PRODUCT BULLETIN

Subject: LP2017 Design Change
Date: 01-07-10
Bulletin Number: 10-0107 LP2017 Design Change

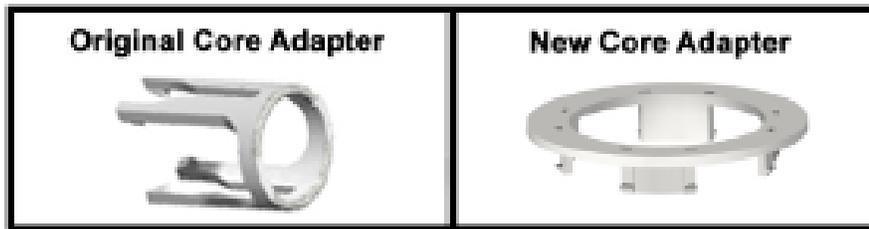
Champion Laboratories, Inc / Luberfiner has initiated a design change on part number LP2017. This is a running change.

LP2017 is now being shipped with the new core adaptor and instructions. This new version will fit the 2009 and 2010 Ford Super Duty 6.4L engines as well as all previous application years. The new filter can be identified with the label on the box that says (FITS 2003-2010).

1. A new “Corer Adapter”  is required to service style A housings. (See illustrations above.) To service style A housings proceed to step 2. To service style B housings discard the core adapter and proceed to step 5.

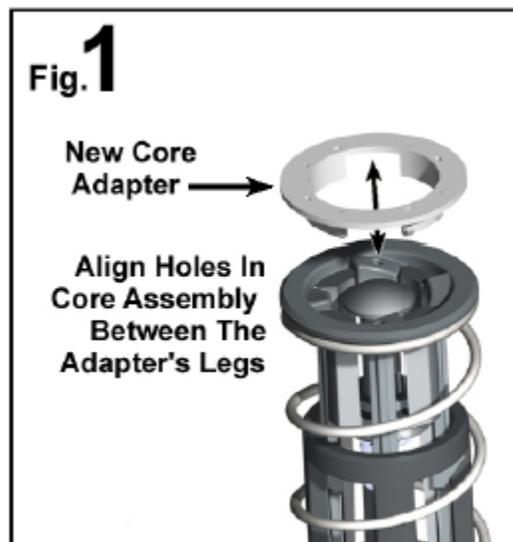
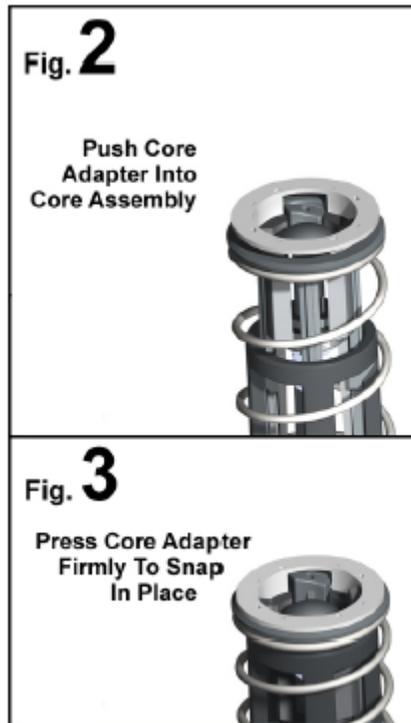
3. Align the holes on top of the core assembly between the legs of the new core adapter. (See Fig 1.)

4. With core adapter in position, (see fig 2), press core adapter firmly to snap in place. (see fig. 3)
